# Durable Compostable Bag (DCB) Manufacturer RFP – Addendum Two

**Issued Date: 3/17/2021**

**For reference purposes only \*NOT TO SCALE\***

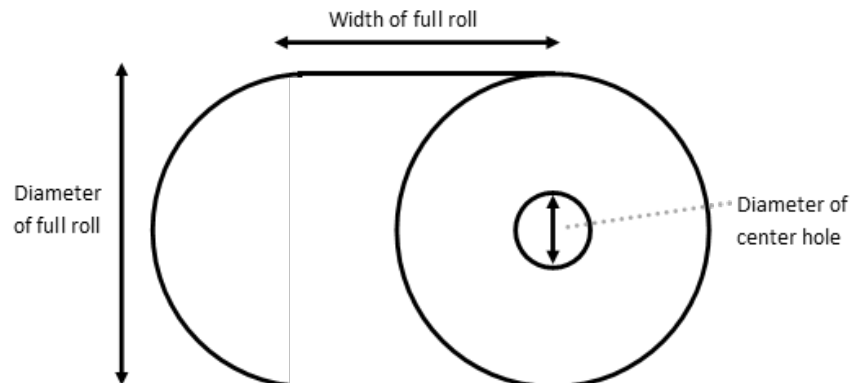
**1. What are the dimensions needed for the rolls of 6- to 8-gallon DCBs to fit into the EcoSafe-MultiRes dispenser (as highlighted in Picture 1 in Attachment B; Section 4.8)?**

A1. The dimensions of the rolls of bags that are currently inserted into the EcoSafe MultiRes dispenser are provided below. This is to assist vendors in determining the component of their proposal regarding providing special rolls of DCBs that will be distributed in these dispensers at county drop-off sites.

Type of dimension	Size
Diameter of full roll of bags	not to exceed 6 3/8"
Width of full roll* *include width of center tube, if included and/or if the tube protrudes from sides of the bag roll	not to exceed 5"
Diameter of center hole in roll	no smaller than 1"

The following diagram has been provided to further describe the size requirements for these rolls. Please note that the diagram is **not** to scale.
